FLOW KIA
AT 1390 RICHMOND ROAD

ARB SUBMISSION

DESIGN
DEVELOP

03 | 18 | 2024

PROPOSED REVISED ELEVATIONS

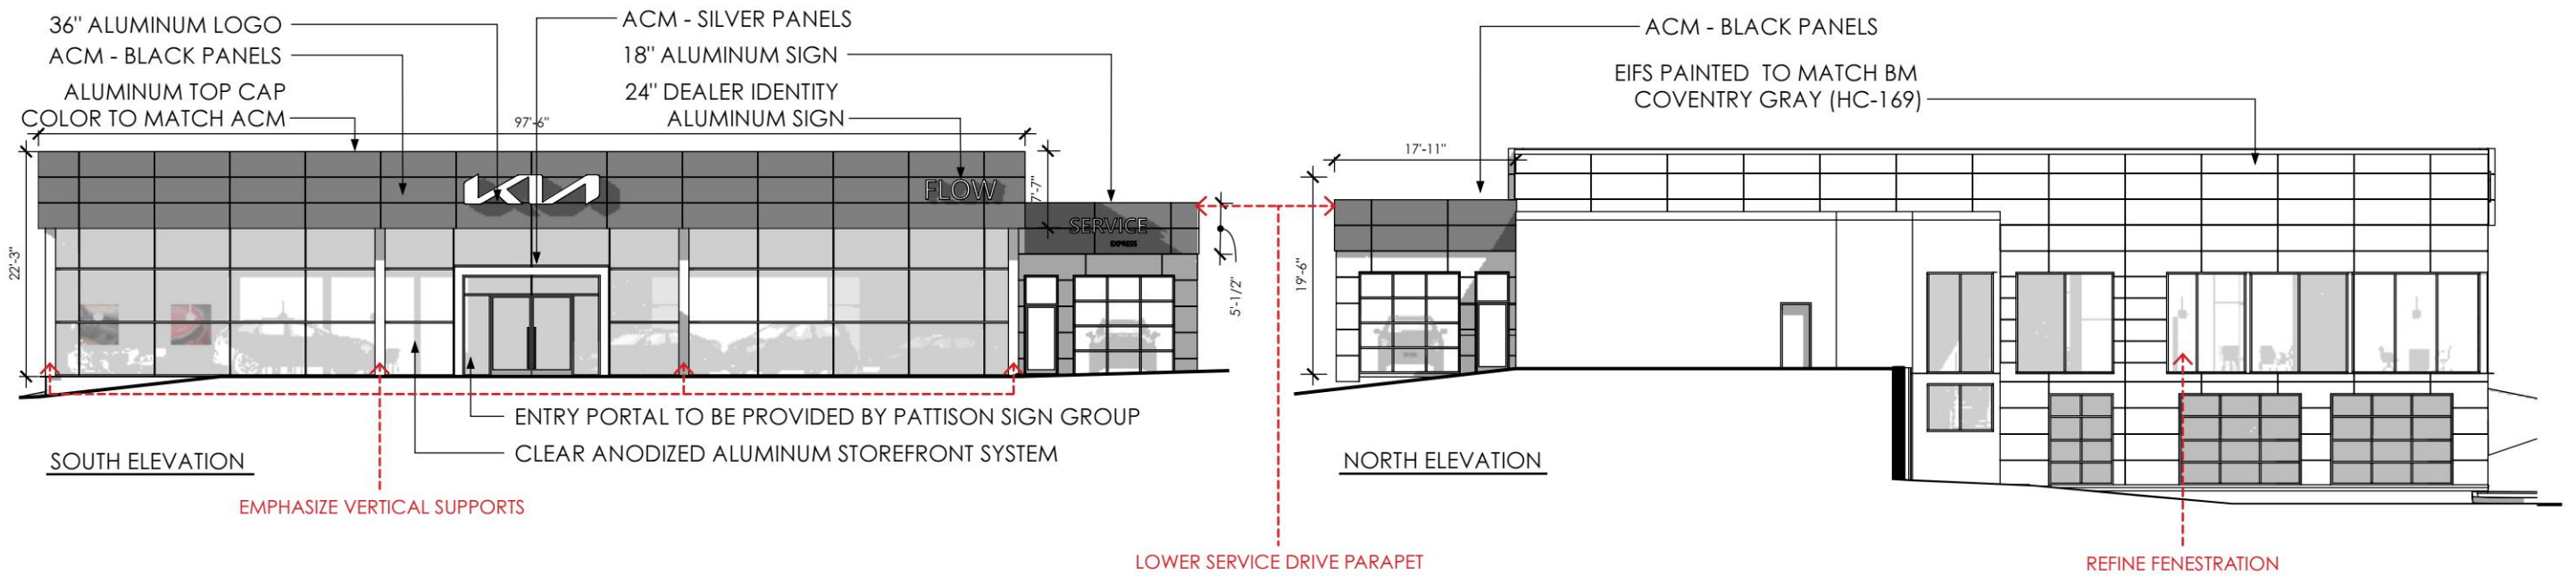
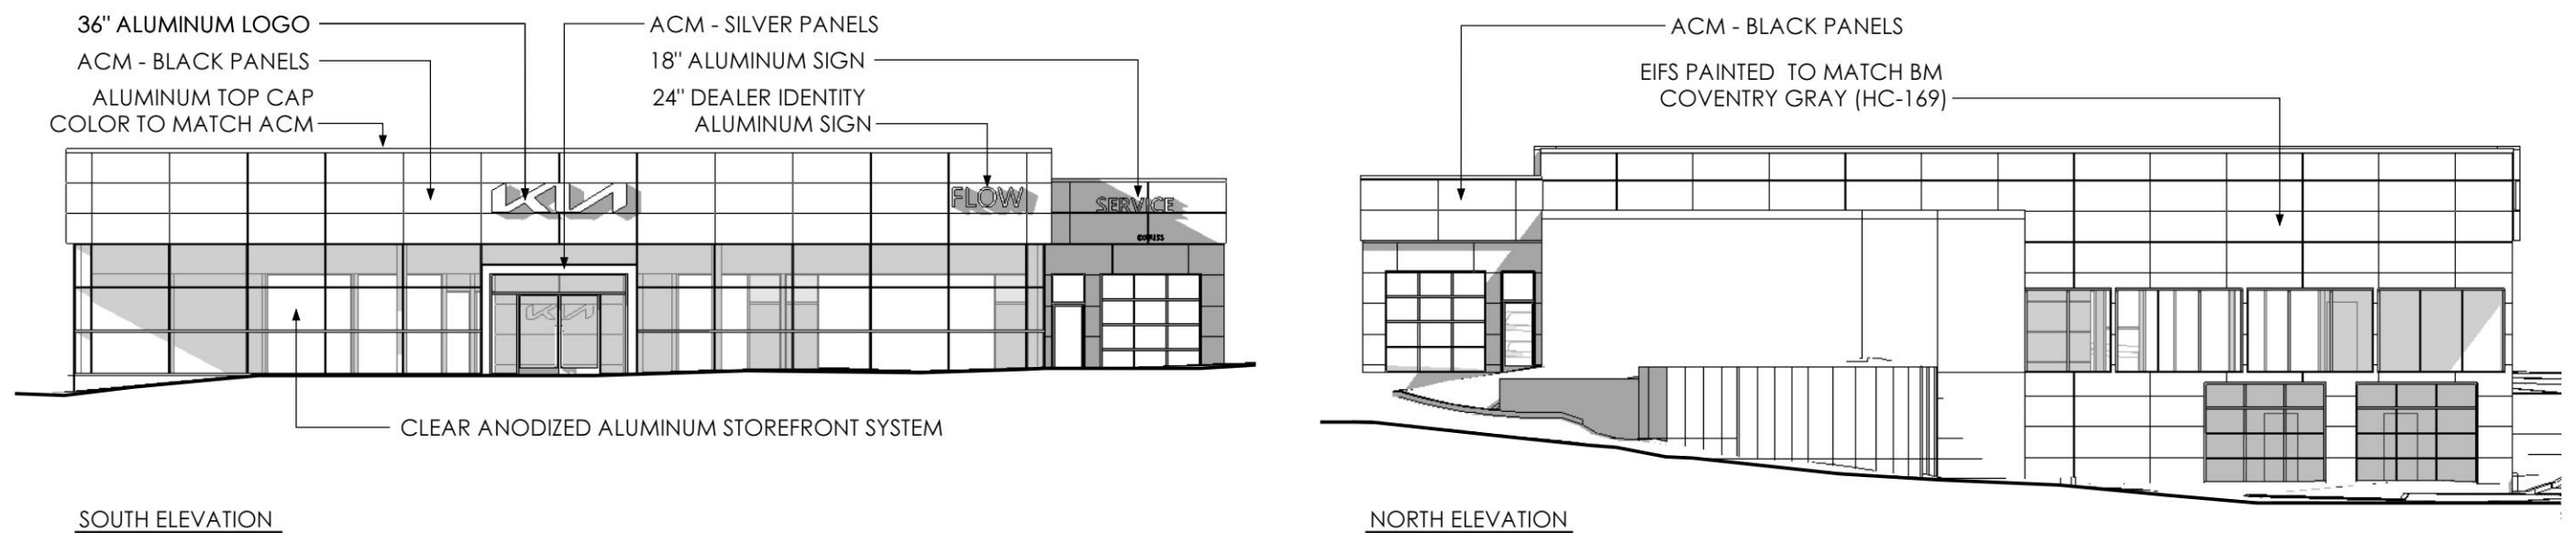
REVISION 1: GROUND THE BUILDING BY INTRODUCING NEW DIAGONAL SUPPORTS IN THE BRUSHED ANODIZED ALUMINUM MATERIAL
REVISION 2: EMPHASIZE THE VERTICAL SUPPORTS BY BRINGING THE COLUMNS PROUD OF THE CURTAINWALL
REVISION 3: LOWER THE HEIGHT OF SERVICE DRIVE PARAPET
REVISION 4: REFINE THE FENESTRATION ON THE WEST AND NORTH FACADES

PROPOSED REVISED ELEVATIONS

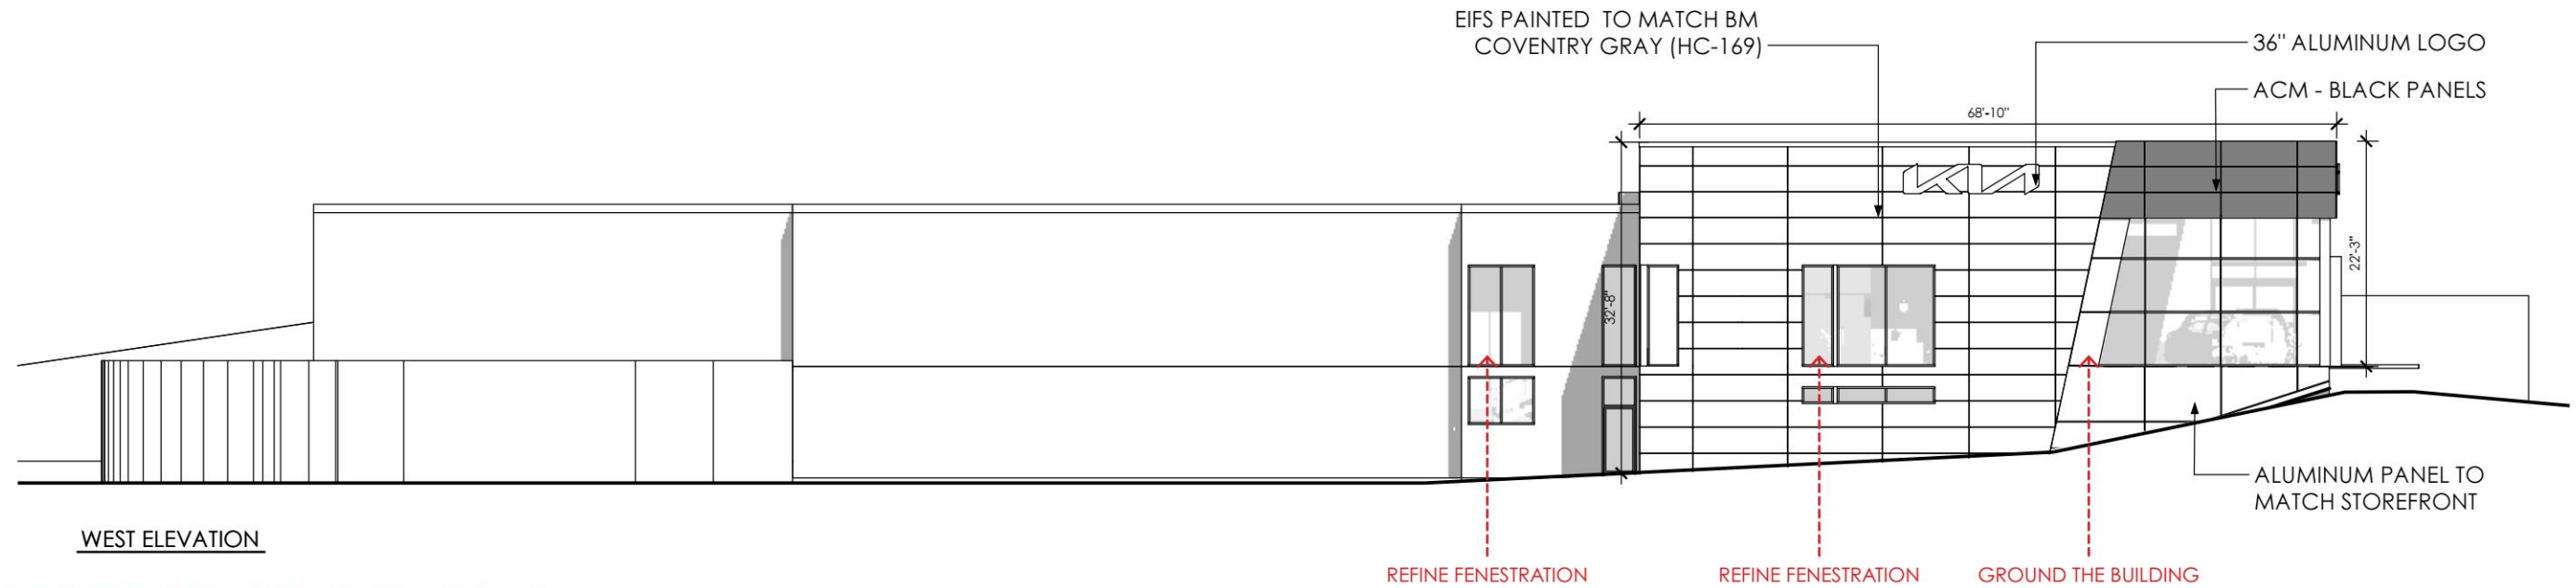
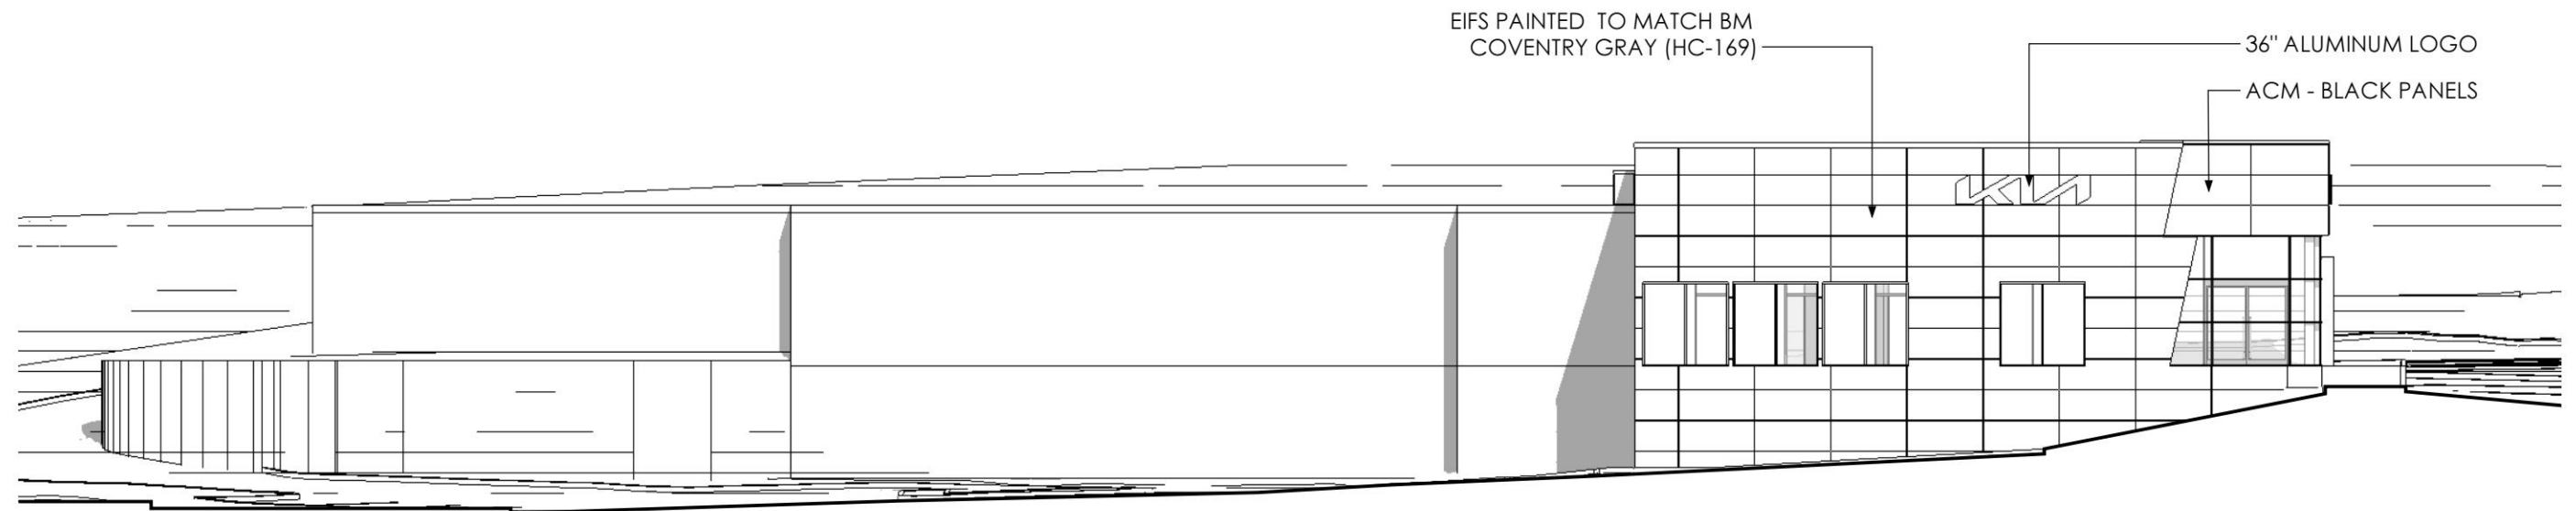
REVISION 1: GROUND THE BUILDING BY INTRODUCING NEW DIAGONAL SUPPORTS IN THE BRUCHES ANODIZED ALUMINUM MATERIAL
REVISION 2: EMPHASIZE THE VERTICAL SUPPORTS BY BRINGING THE COLUMNS PROUD OF THE CURTAINWALL
REVISION 3: LOWER THE HEIGHT OF SERVICE DRIVE PARAPET
REVISION 4: REFINE THE FENESTRATION ON THE WEST AND NORTH FACADES
